**CITY OF NEWTON, MASSACHUSETTS**  
Department of Planning and Development  
Michael J. Kruse, Director

TO: Board of Aldermen

SUBJECT: **#466-06 - RICHARD GRANT** petition for a **SPECIAL PERMIT/SITE PLAN APPROVAL AND EXTENSION OF NONCONFORMING STRUCTURE** for an addition constructed to the rear of an existing three-family dwelling with an attached two-car garage at **62-64 ELM STREET**, Ward 3, **WEST NEWTON**, on land known as Sec. 23, Blk 24, Lot 4, containing approximately 16,600 s.f. of land in a district zoned Multi Residence 1.

## PLAN OF LAND IN NEWTON, MA

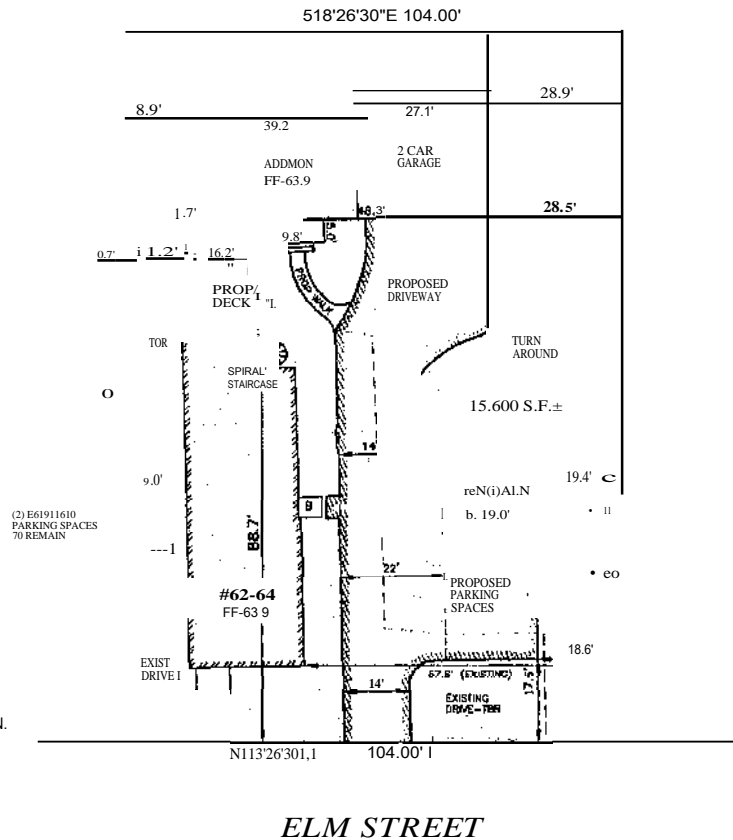
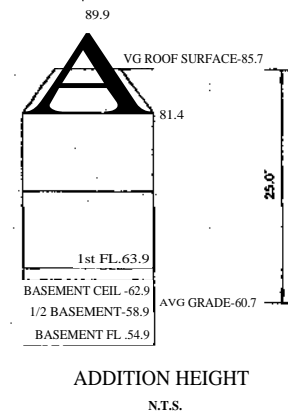
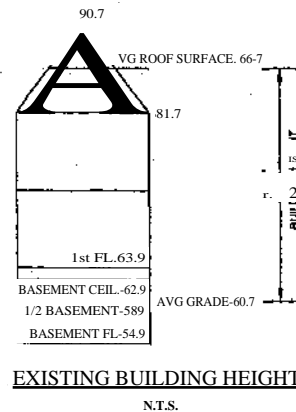
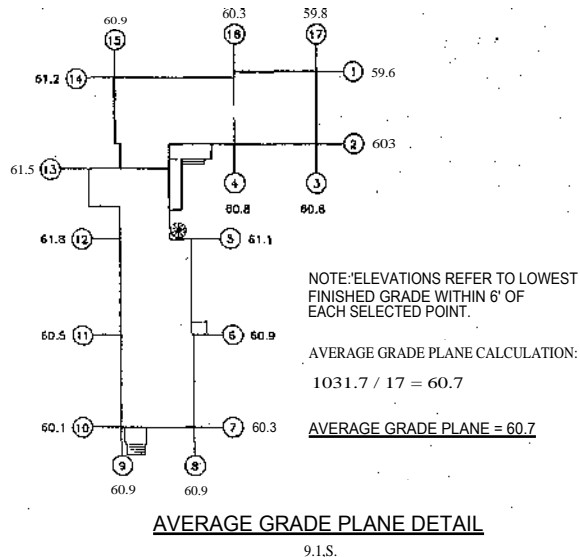
In addition, neither the existing drive to these spaces, nor the associated curb cut have been dimensioned on plan. As a result, it is not possible to determine whether these conform to Section 30-19(g)(3) or whether a waiver per Section 30-19(m) is necessary.

1. As a public benefit, the existing bituminous concrete sidewalk [which is in poor condition] should be replaced with new cement concrete sidewalk and granite curbing.
2. The site plan is missing the City's Standard Construction driveway detail. Driveway aprons must comply with ADA, and the Architectural Access Board's Standards.
3. Prior to Occupancy permit being issued, an As-Built Plan shall be submitted to the Engineering Division in both digital format and in hard copy. The plan should show all utilities and final grades, any easements and final grading.
4. If a Certificate of Occupancy is requested prior to all site work being completed, the applicant will be required to post a Certified Bank Check in the amount to cover the remaining work. The City Engineer shall determine the value of the uncompleted work.

- **revise the landscape plan to provide additional screening,**
- **revise the Site Plan to show the replacement of the sewer service, sidewalk, and provide the driveway detailed required by the Engineering Department, and**
- **revise the site plan to reduce the amount of impervious surface on the lot.**

Figure 3. Existing tandem driveway on north side of property

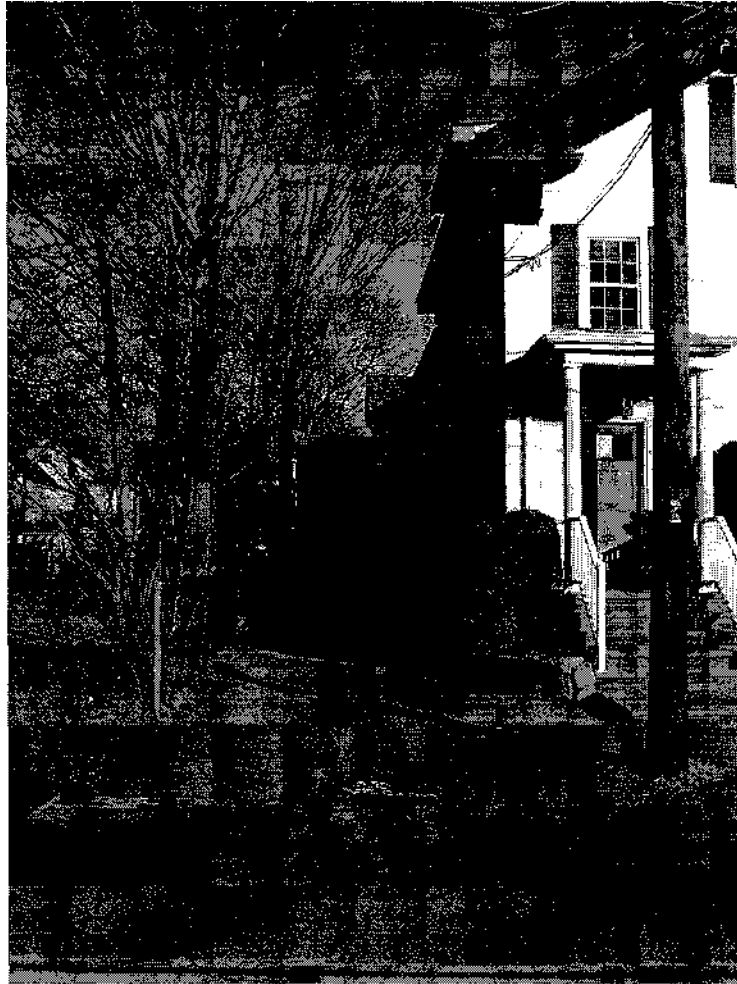
The tandem parking area is not proposed to be screened at all as the pavement is close to or on the side lot line and there is no physical space to install landscape materials. ***The Planning Department recommends that these parking stalls, driveway and curbcut be removed and this area be planted with grass and other landscaping materials.***

Given the proposed size of the units and the number of bedrooms, the Planning Department believes that as proposed the extension of this three-family use is expected to bring more vehicles and vehicle trips into the site. For this reason, the Planning Department recommends the petitioner remove the tandem driveway on the north property line to reduce the potential safety issues and to reduce the potential for residents to have excess vehicles on site. The parking area is redundant to what is being proposed elsewhere on site and is a potential safety hazard for pedestrians and

vehicles as the drivers will have to back out, blindly for a portion of the way, out into public walkway and Elm Street.

***The Planning Department continues to recommend that the existing parking area, driveway and curbcut on the north side of the building be removed and that the surface parking be moved further back, to comply with the front setback requirements. Further, the Planning Department recommends that the petitioner look at possible ways to redesign the new parking facilities to minimize the amount of excess impervious surface.***
